RHODE ISLAND CONTRACT NO.2020-CB-015

Bridge Group 10 - I-295

NOTICE TO PROSPECTIVE BIDDERS

ADDENDUM NO. 3 Prospective bidders and all concerned are hereby notified of the following changes in the Plans, Specifications, Proposal and Distribution of Quantities for this contract. These changes shall be incorporated in the Plans, Specifications, Proposal and Distribution of Quantities, and shall become an integral part of the Contract Documents.

TITLE OF SKETCH
BRIDGE GROUP 10 - I-295
 GEORGE WASHINGTON HIGHWAY BRIDGE NO. 074701
JOINT DETAILS - 1

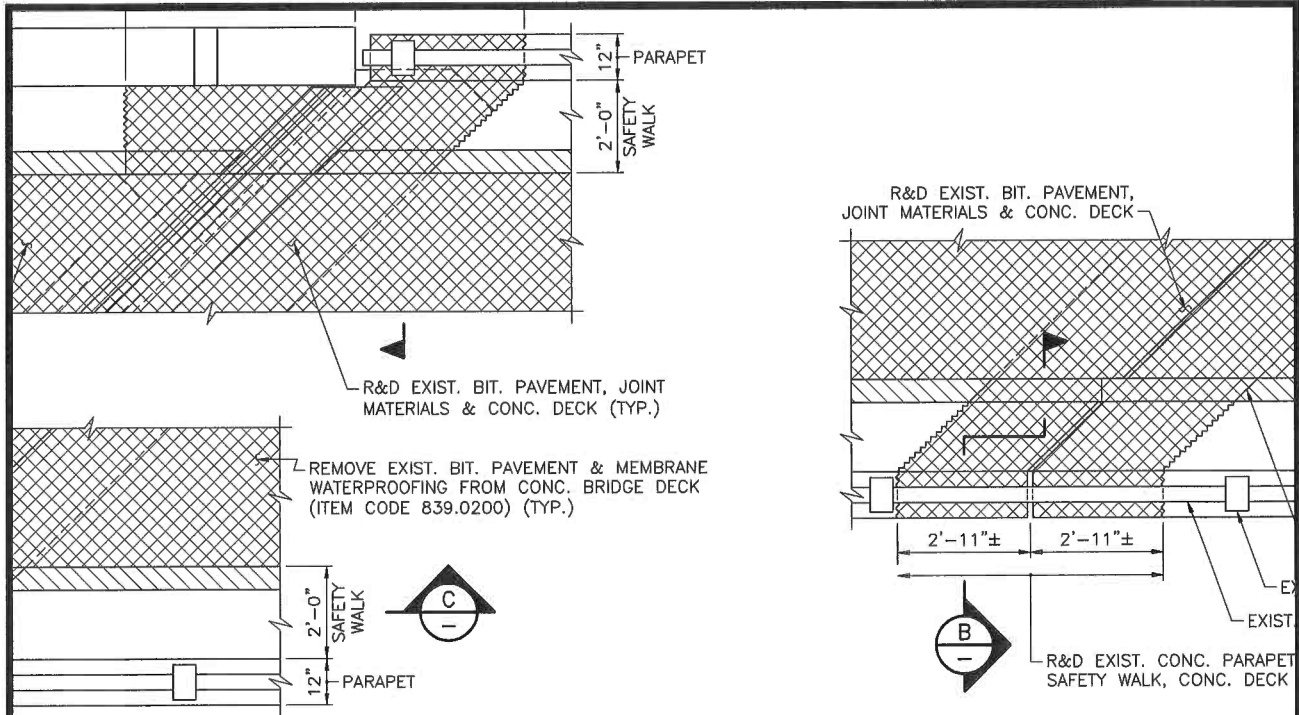
17. Sheet No. 57 - George Washington Highway Bridge No. 074701 - Joint Details - 1
Revise Sheet No. 57 as shown on Sketch No. 24(R-1) attached to this Addendum No. 3. The pavement structure at approaches has been changed.

<p>RI CONTRACT NO.</p> <p>2020-CB-015</p>
<p>SKETCH NO.</p> <p>28</p>
<p>REVISION TO</p> <p>SHEET NO. 68</p>

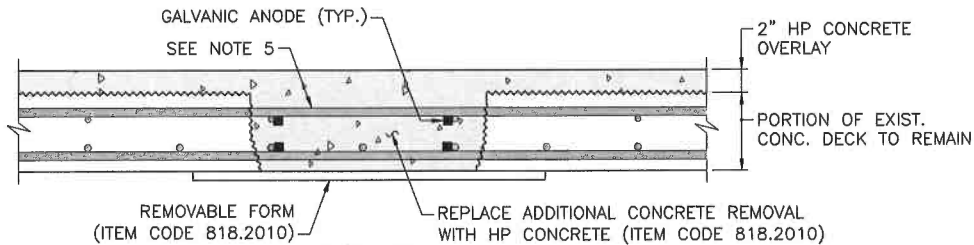
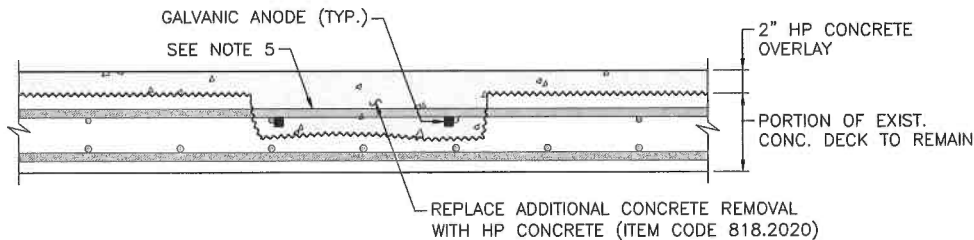
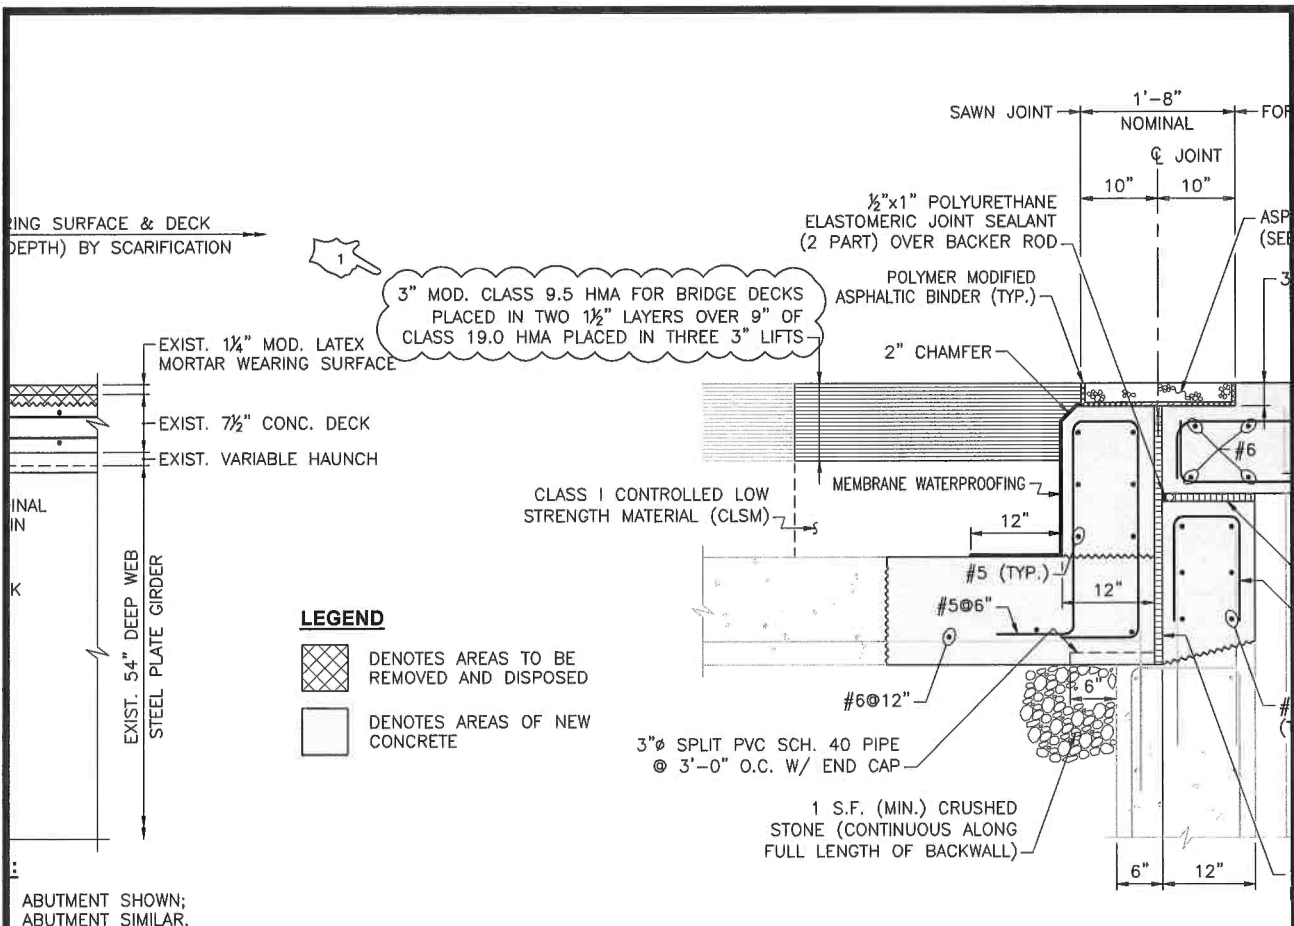
21. Sheet No. 68 - Douglas Pike Ramp Bridge Nos. 079701 & 079821 - Bridge Deck Repair Details
Revise Sheet No. 68 as shown on Sketch Nos. 28(R-1) and 29(R-1) attached to this Addendum No. 3. Bridge Deck Repair Note No. 6 has been revised and a note has been added regarding spacing of galvanic anodes.
